HISTORIC AND DESIGN REVIEW COMMISSION

HDRC CASE NO: 2021-004
ADDRESS: 211 E HUISACHE AVE
LEGAL DESCRIPTION: NCB 3085 BLK 1 LOT 16
ZONING: MF-33,H
CITY COUNCIL DIST.: 1
DISTRICT: Monte Vista Historic District
APPLICANT: Darrell Burghard/HEARTSTONE HOMES LLC
OWNER: HEARTSTONE HOMES LLC
TYPE OF WORK: Rear accessory structure modifications
APPLICATION RECEIVED: January 05, 2021
60-DAY REVIEW: Not applicable due to City Council Emergency Orders
CASE MANAGER: Stephanie Phillips

The applicant is requesting a Certificate of Appropriateness for approval to add stucco over the asbestos siding on the existing garage.

A-5	SHEET: 5	SCALE:	DATE: 12-17-20	DRAWINGS PROVIDED BY: JONATHAN VALEN 310-941-5919 HEAVYMETAL LLC	PROJECT DESCRIPTION: HEART & STONE 211 E. HUISACHE AVE. SAN ANTONIO TX 78212	SHEET TITLE: ORIGINAL ELEVATIONS	NO.	DESCRIPTION	BY	DATE

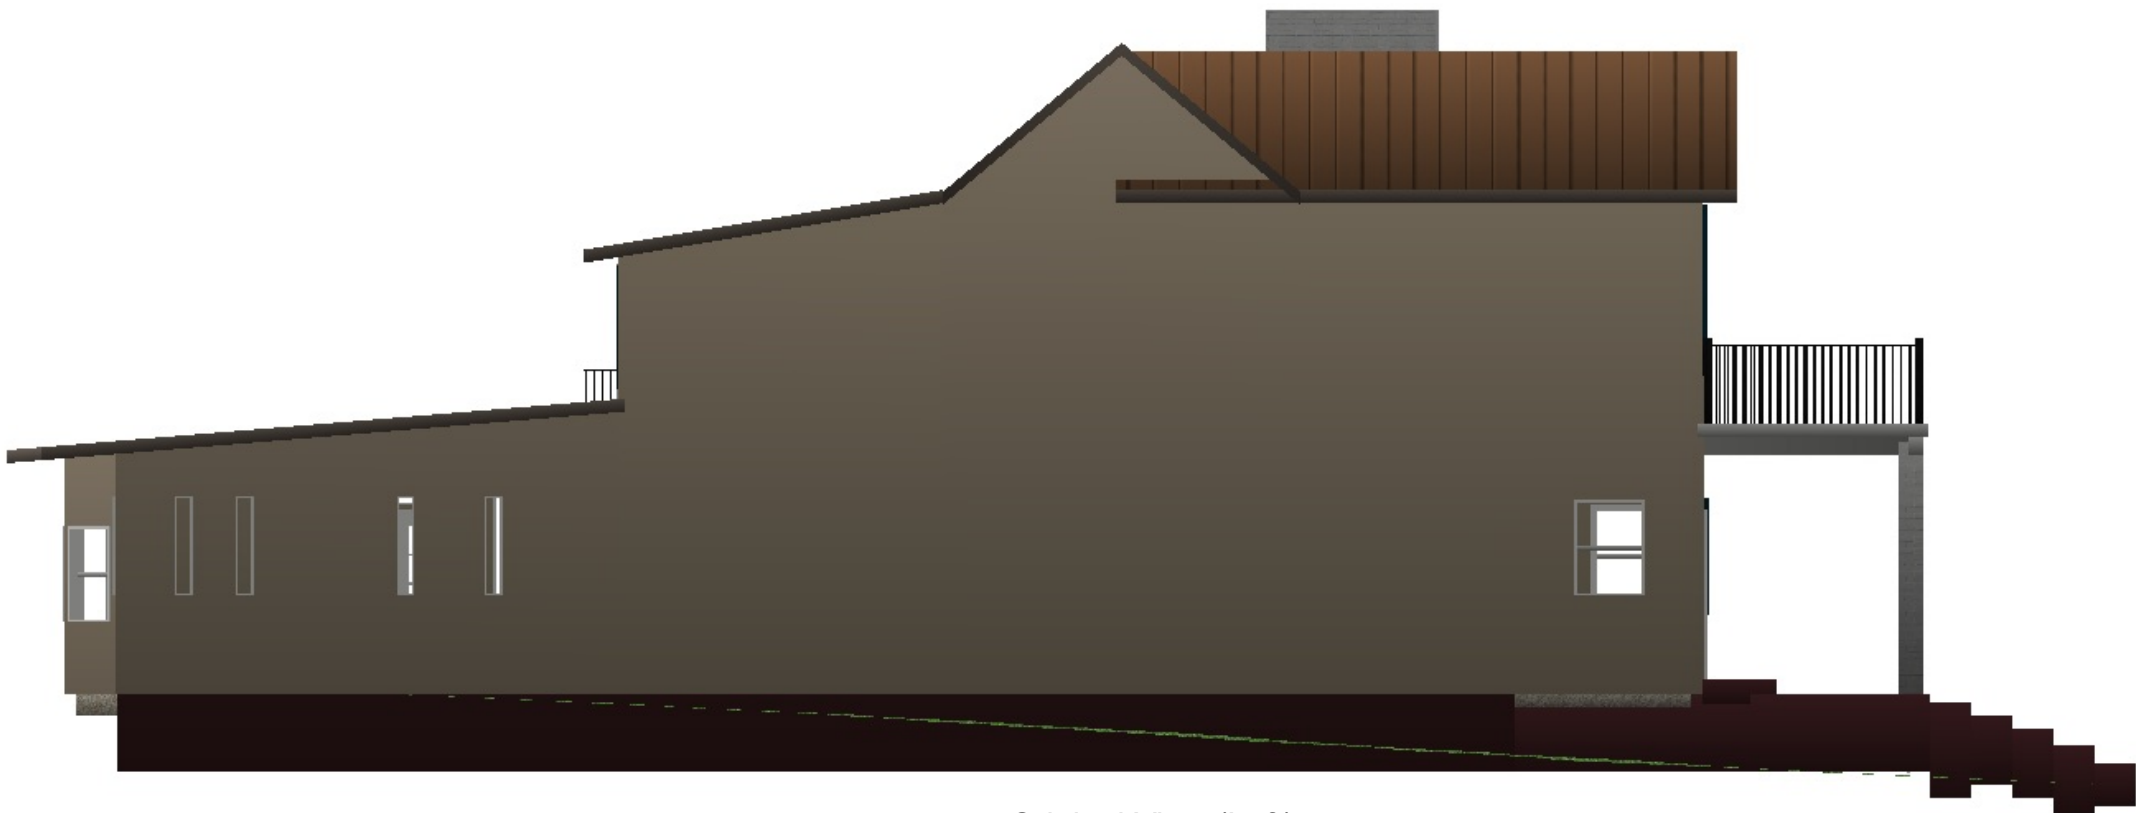
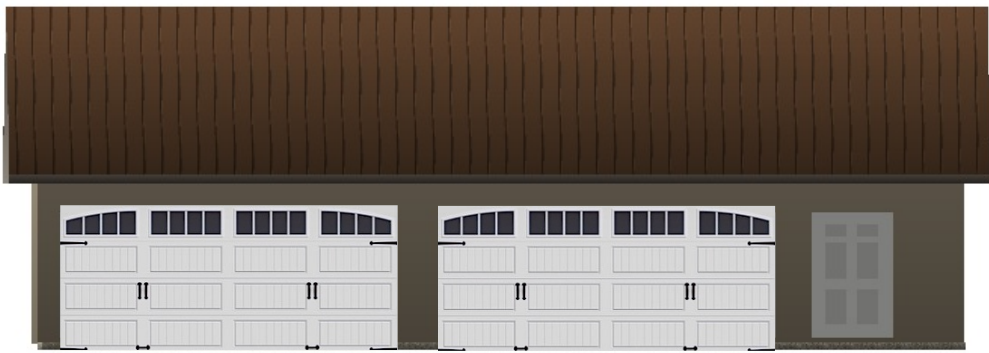
- b. The existing rear structure is clad in asbestos siding. An ideal remediation treatment for asbestos is for it to be carefully removed by a professional experienced in handling toxic materials. An alternative to remediation by removal is encapsulation, or retaining the existing material and coating it in paint or another substance to significantly eliminate the possibility of its disturbance. Staff generally supports one of these two methods.

- c. **ACCESSORY STRUCTURE MODIFICATIONS** – The applicant has proposed to stucco over the existing siding on the rear accessory structure. The primary siding is lap asbestos, with a small portion containing non-original wood. As noted in finding a, the structure has been modified over the years based on Sanborn Maps, with its footprint nearly tripling with modifications to wall plane locations. While staff finds that the structure is still contributing to the district, largely due to its height and siting, the original footprint and materials have been significantly altered. As noted in finding b, either full removal of asbestos or encapsulation with paint or another substance are preferred methods of handling the presence of the material. Though coating in stucco is not a preferred method, such a treatment will result in encapsulation of the material. Based on these specific modifications to this particular rear structure, as well as the presence of stucco on the primary structure on site, staff finds that the request is acceptable.

Staff recommends approval based on findings a through c.
